PARTS & SERVICE NEWS

REF NO.	AT00244
DATE	Nov. 27, 2000
(C)	Page 1 of 11

SUBJECT: INTRODUCTION OF LOW OPERATOR COMPARTMENT NOISE SPEC. PARTS FOR HD325/405-6

PURPOSE: To introduce newly prepared "low compartment noise spec. parts" for installation on HD325-6 and HD405-6 dump trucks

Fig. 8 (Drawing for installation of the plates: The above drawing is a bottom view, when looked up from underneath.)

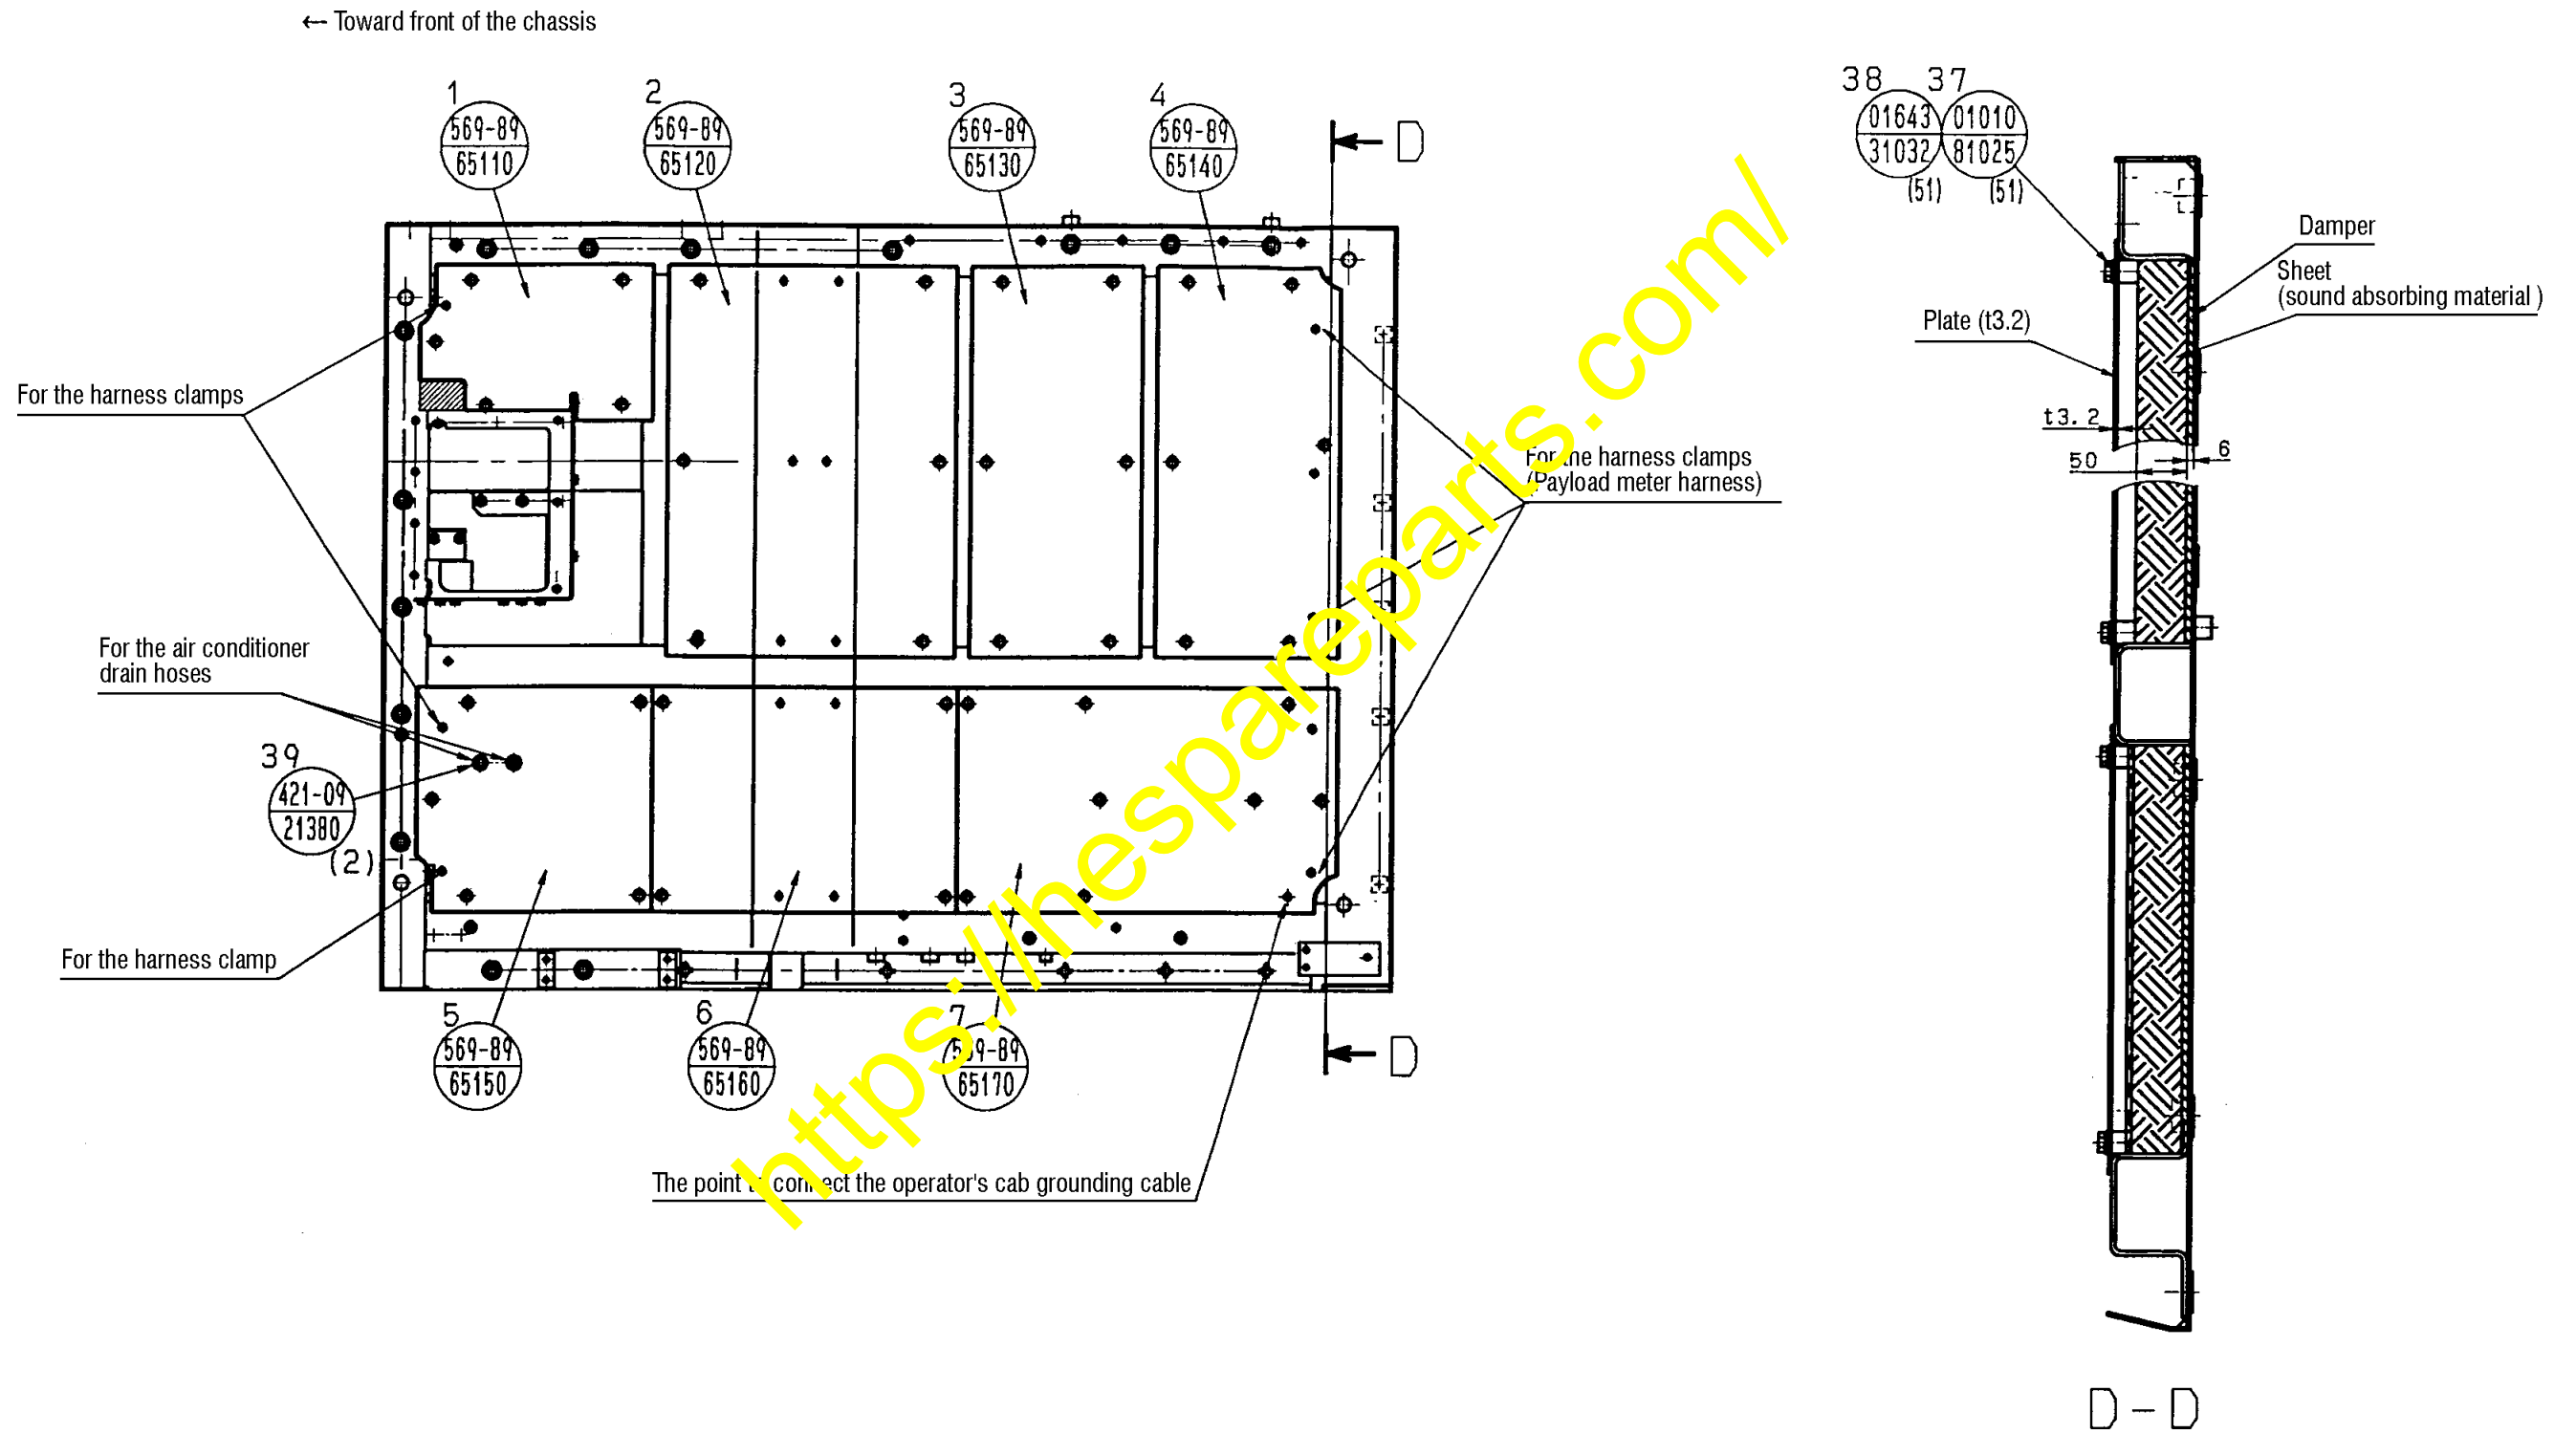
Install the plates ① thru ⑦ onto the bottom surface of the operator's cab floor using bolts ㉗ (01010-81025) and washers ㉘ (01643-31032).

At this time, install the removed harness clip to the plate. Also, install the operator's cab grounding cable located in the rear section of the cab to the plate.
